Town of Hilton Head Island

Design Review Board Meeting

**St. James Baptist Church
Union Cemetery Road
Final
Response Letter to Conditions
October 28, 2025
DRB-001018-2025**

**St. James Baptist Church
Union Cemetery Road
Final - Plan Set
October 28, 2025
DRB-001018-2025**

ROOF PLAN
A.1.4

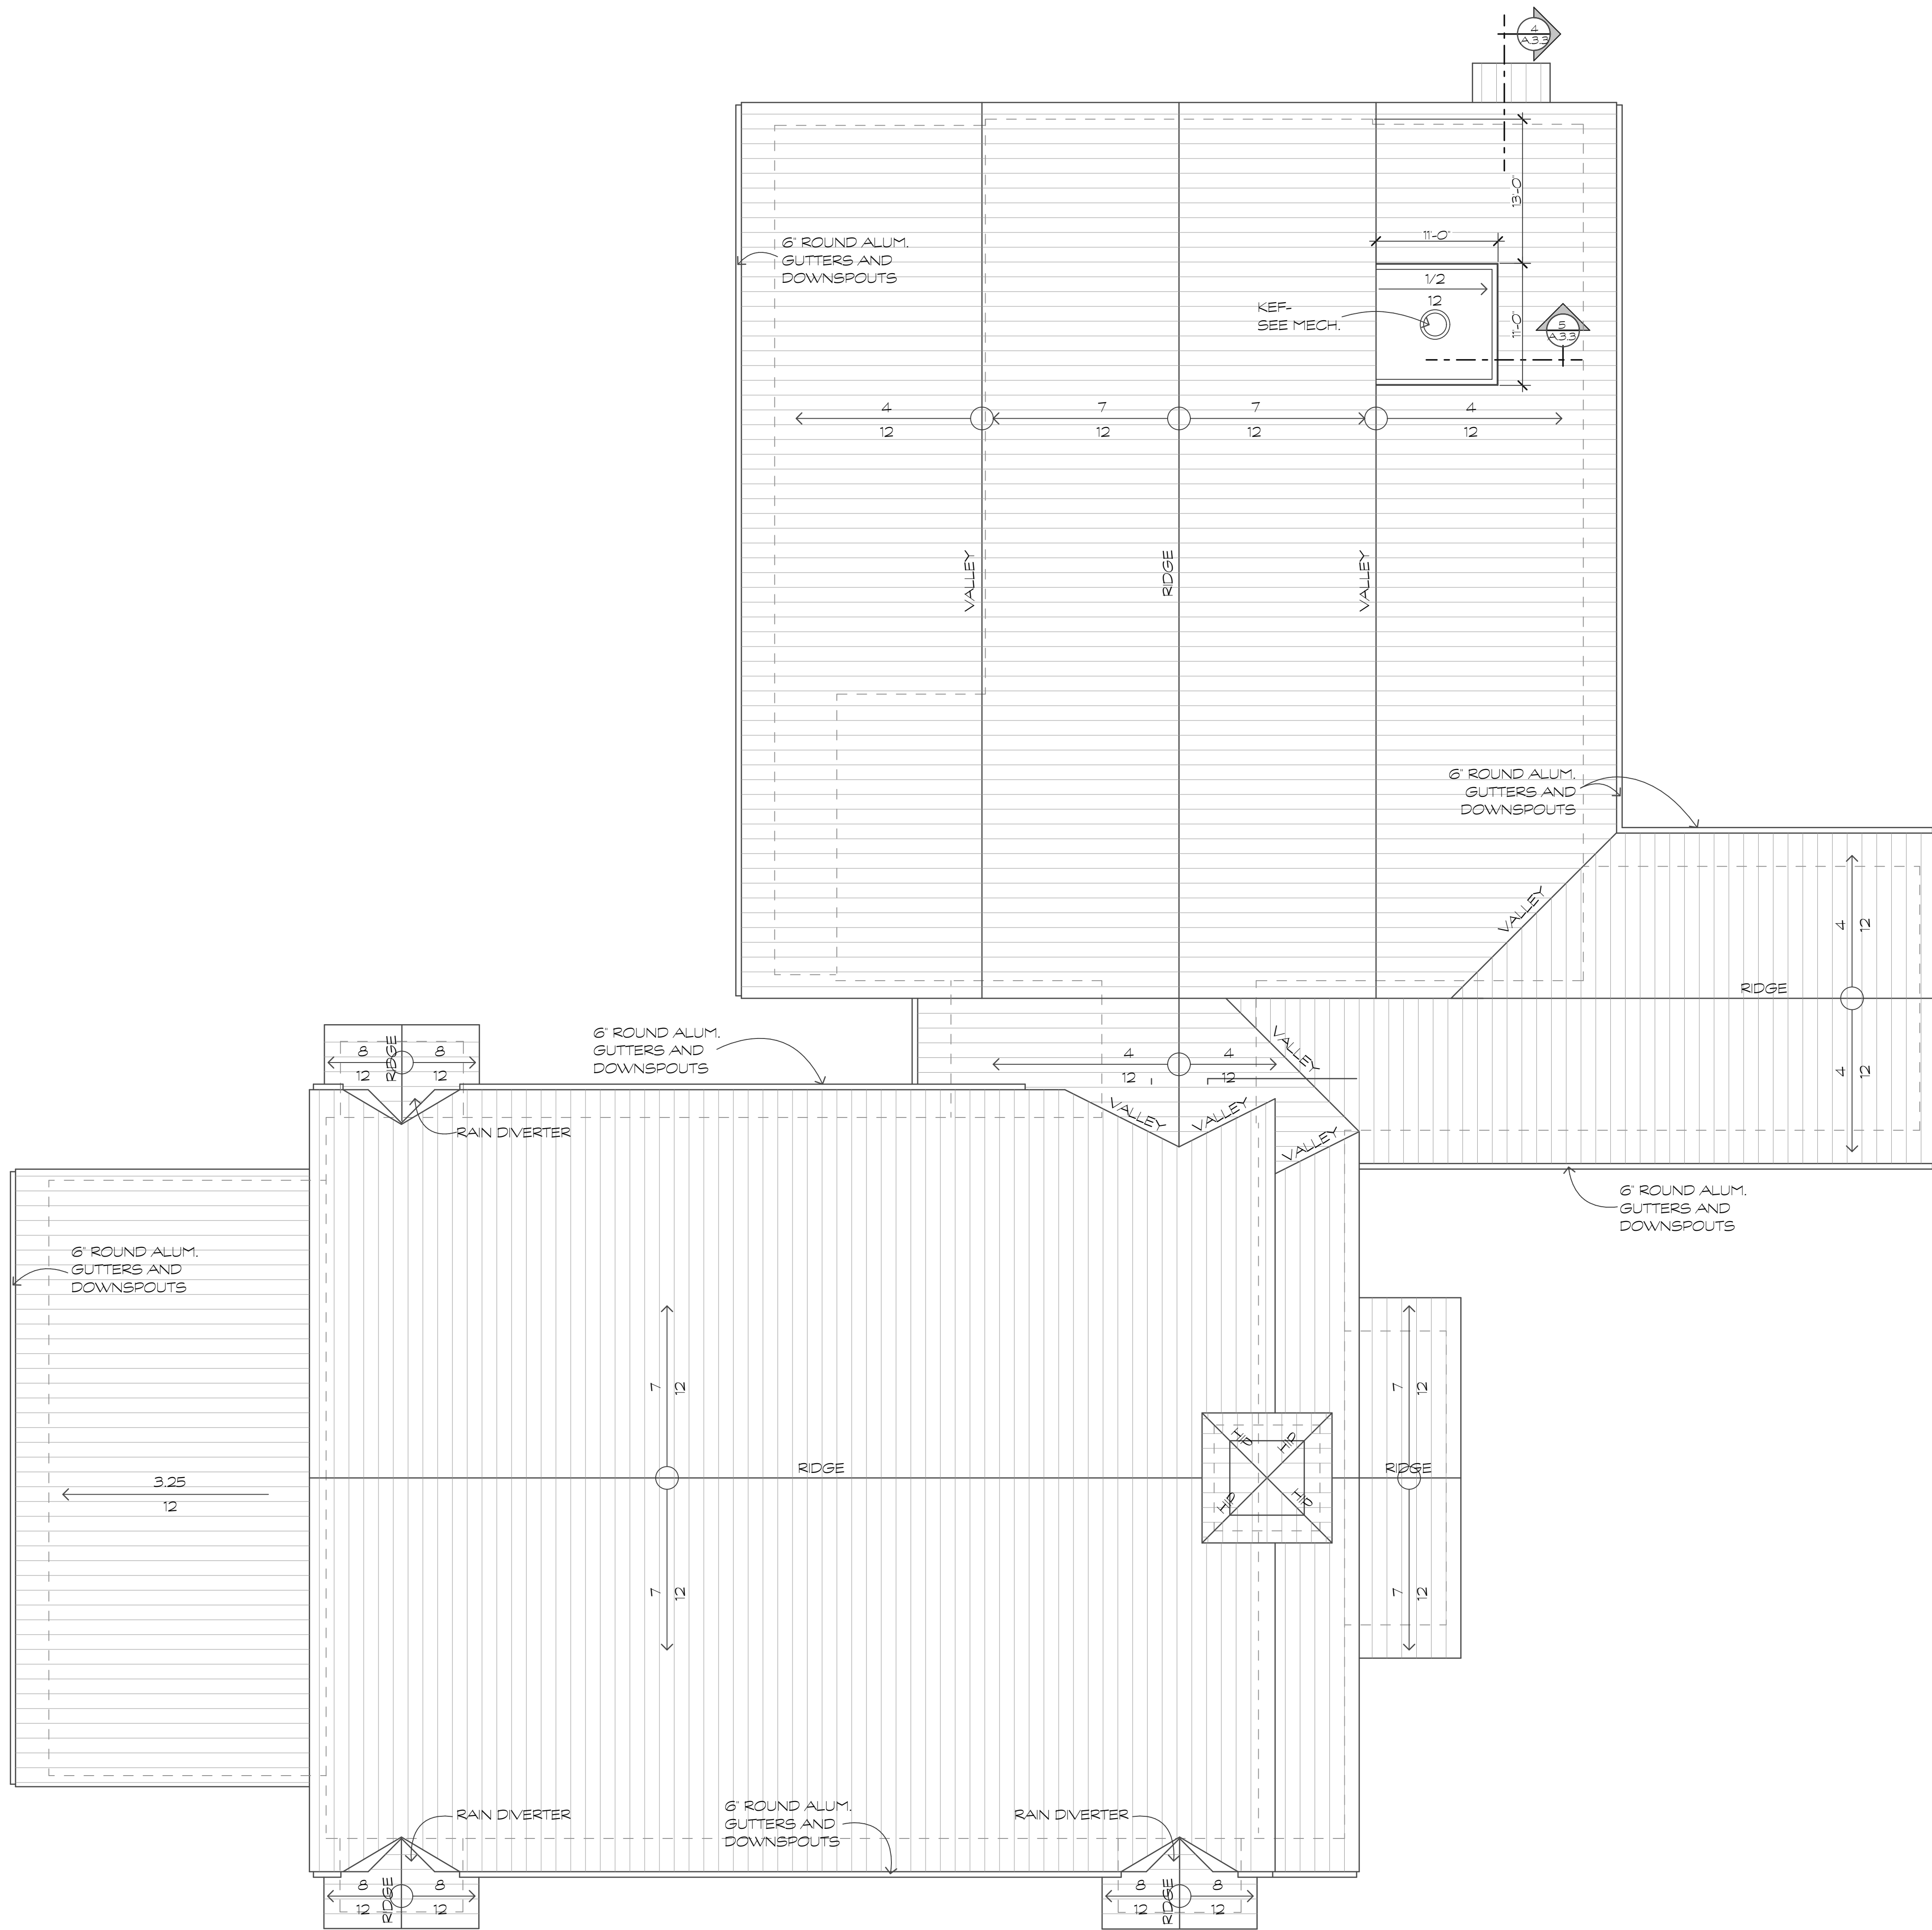
5. Show the hood screen on the roof plan. *We have added this detail to the roof plan.*
6. Show gutters/downspouts on the roof plan and elevations. *We have added the gutters and downspouts to the roof plan and elevations.*

Planting 06

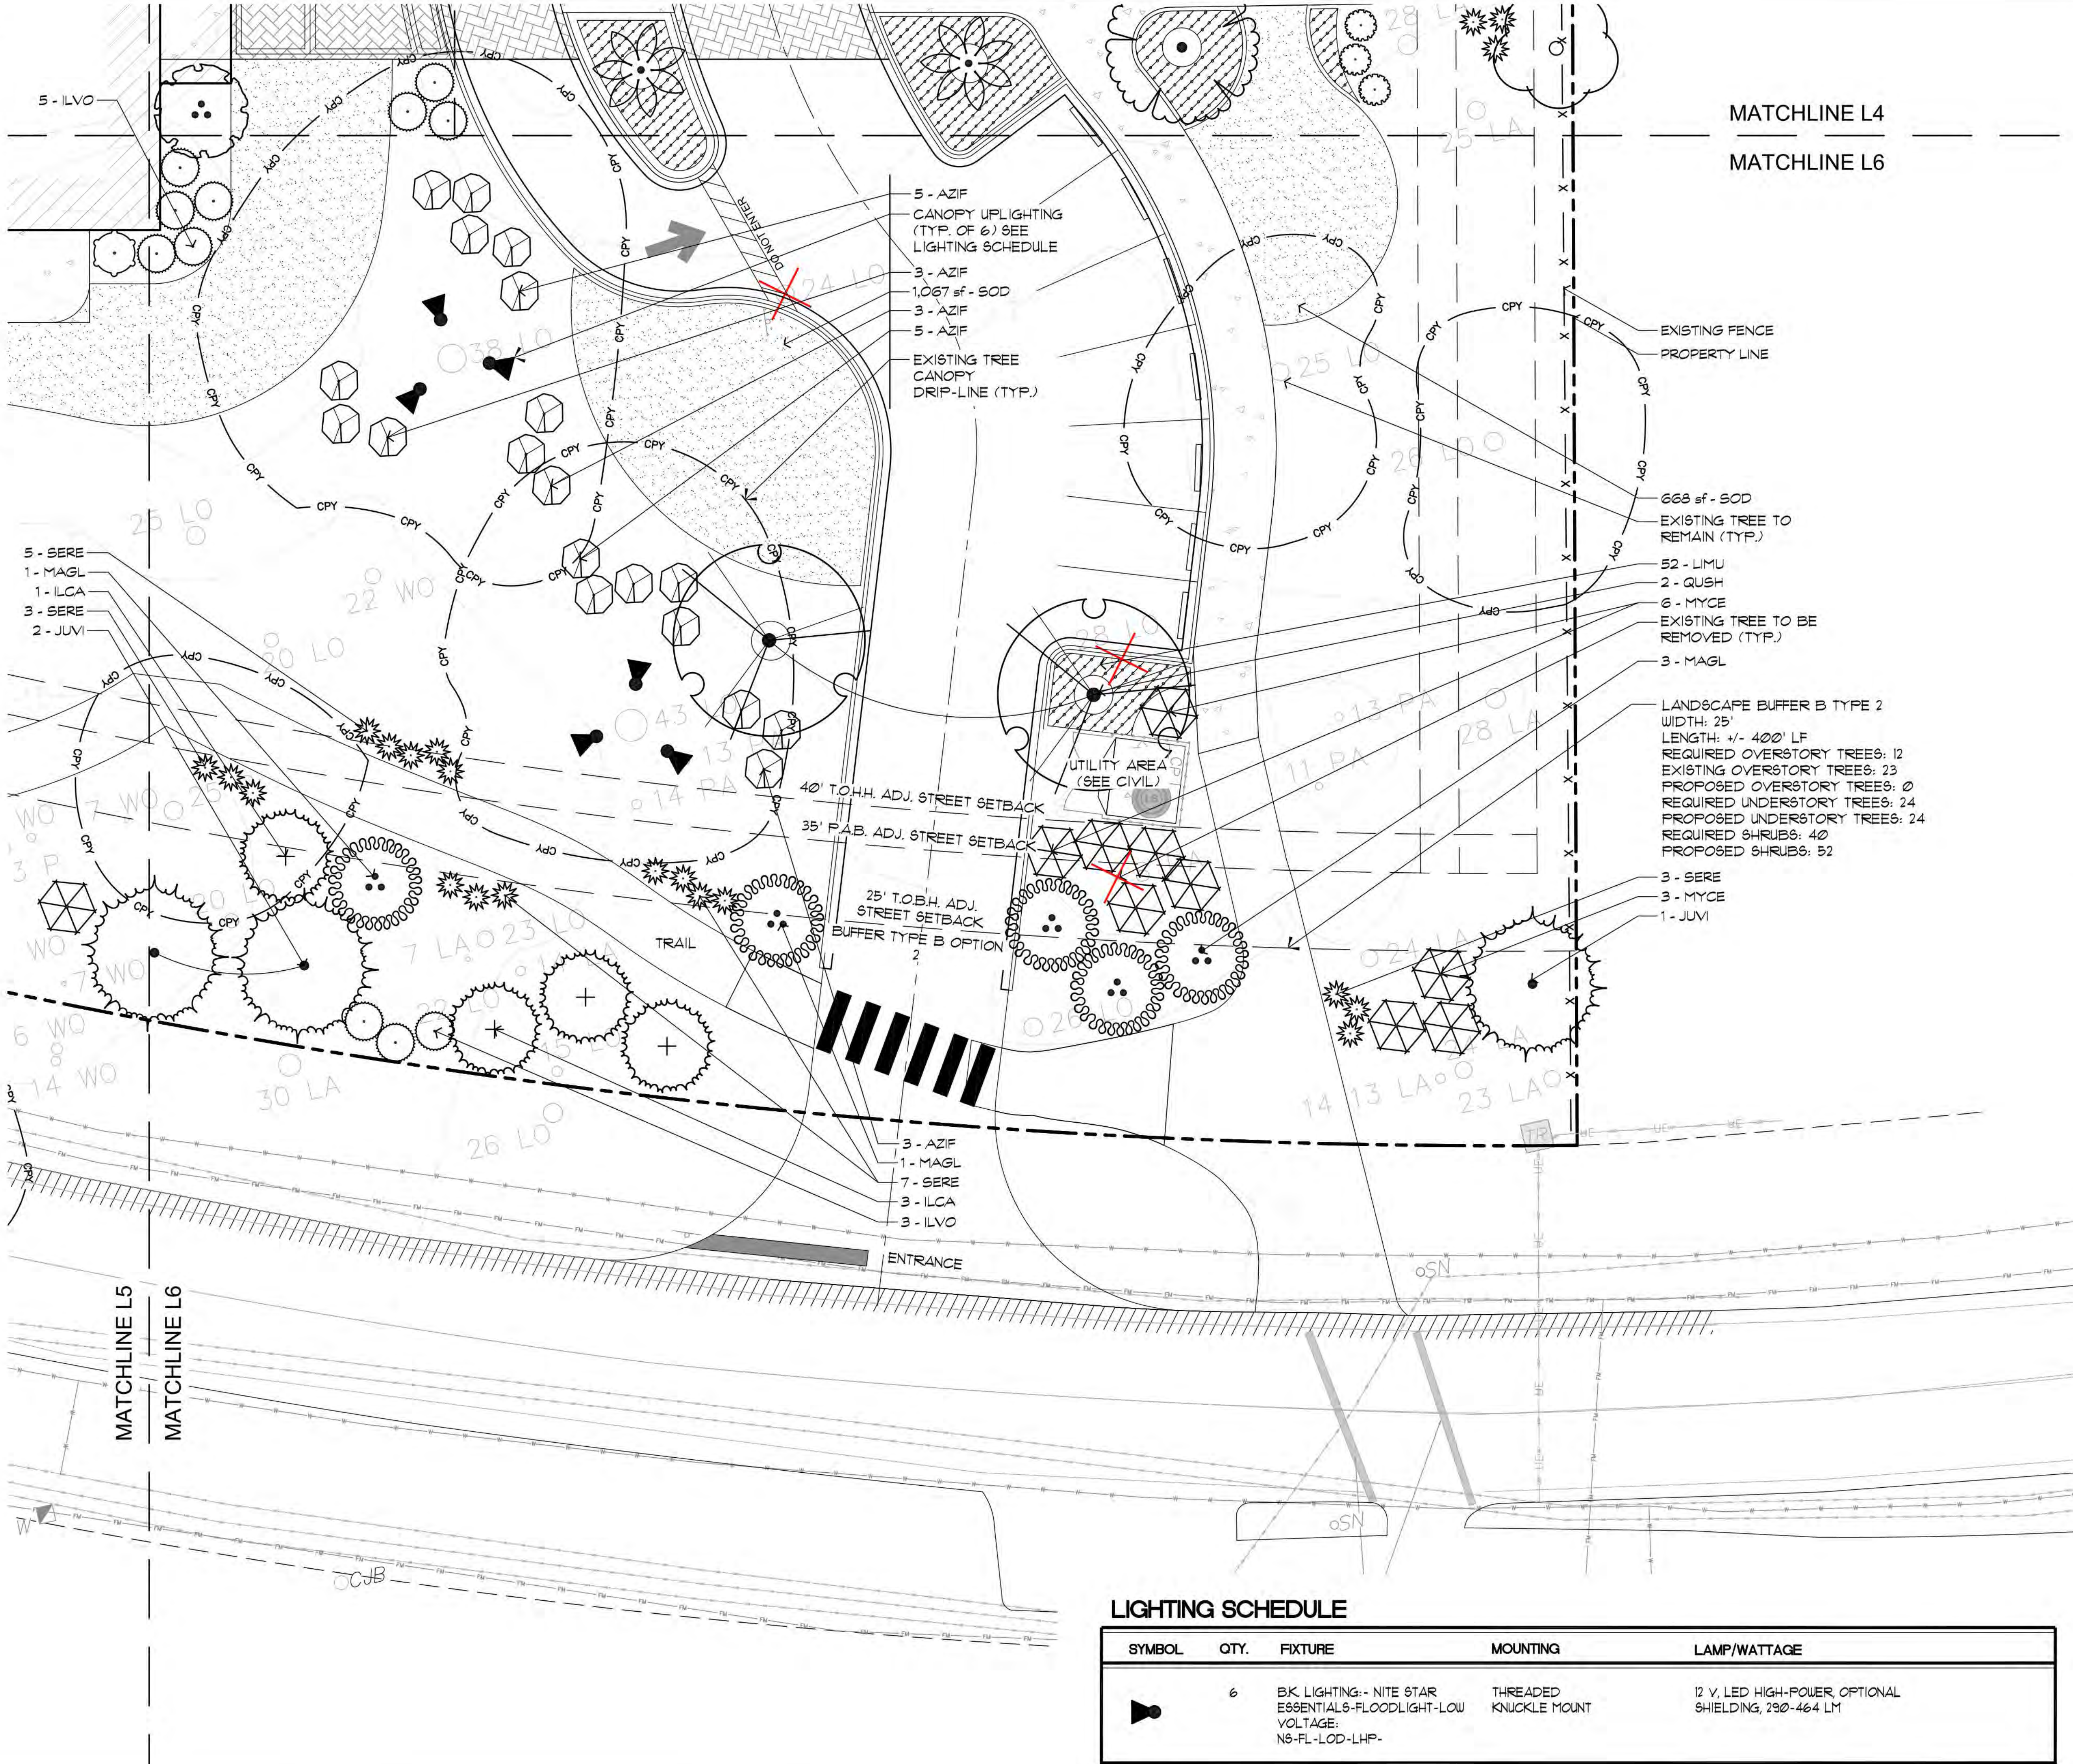
7. Consider uplighting of the mature oaks on the site. *We have added (6) up lights to (2) of the mature oaks on the site. See the revised landscape plan.*
